NY33.4 - 235 Wicksteed Avenue - Temporary Use Zoning By-law Amendment - Decision Report – Approval

From: Leaside Towers Tenants Association <leasidetowersta@gmail.com>
Sent: January 29, 2026 9:14 PM
To: Councillor Chernos Lin <Councillor_ChernosLin@toronto.ca>; Diane Pi <Diane.Pi@toronto.ca>
Subject: [External Sender] Development Application for [235 Wicksteed Avenue](#)

Exhibit 3: Haul routes for cement deliveries

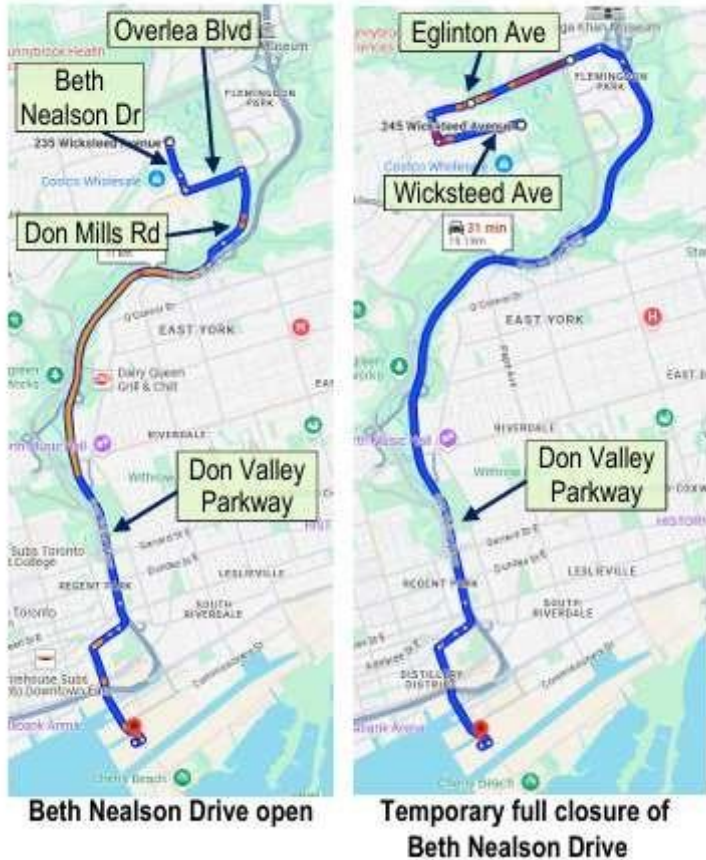
As a tenants association representing 2,500 residents living along Overlea Boulevard, many with children attending Valley Park Middle School and Marc Garneau Collegiate at Don Mills Road and Overlea, the LTTA does not believe it is safe, or even necessary, for the applicant to reintroduce haul routes that include these schools.

With 1,045 students at Valley Park and 1,755 students at Marc Garneau, respectively; with the Don Mills and Overlea intersection already designated as both a [School Safety Zone](#) and a [Community Safety Zone](#); and the City's [Renewing Overlea Boulevard project](#) primary goal being to "Improve safety for everyone," we ask you to reject Don Mills Road / Overlea Boulevard / Beth Neilson Drive being used as a haul route by this applicant.

Instead, the LTTA requests that the applicant's proposed "temporary" haul route, using Eglinton Avenue, Brentcliffe Road, and Wicksteed Avenue be advanced as its [permanent](#) haul route instead, noting that there are no schools along it, and no children's lives to be put at risk.
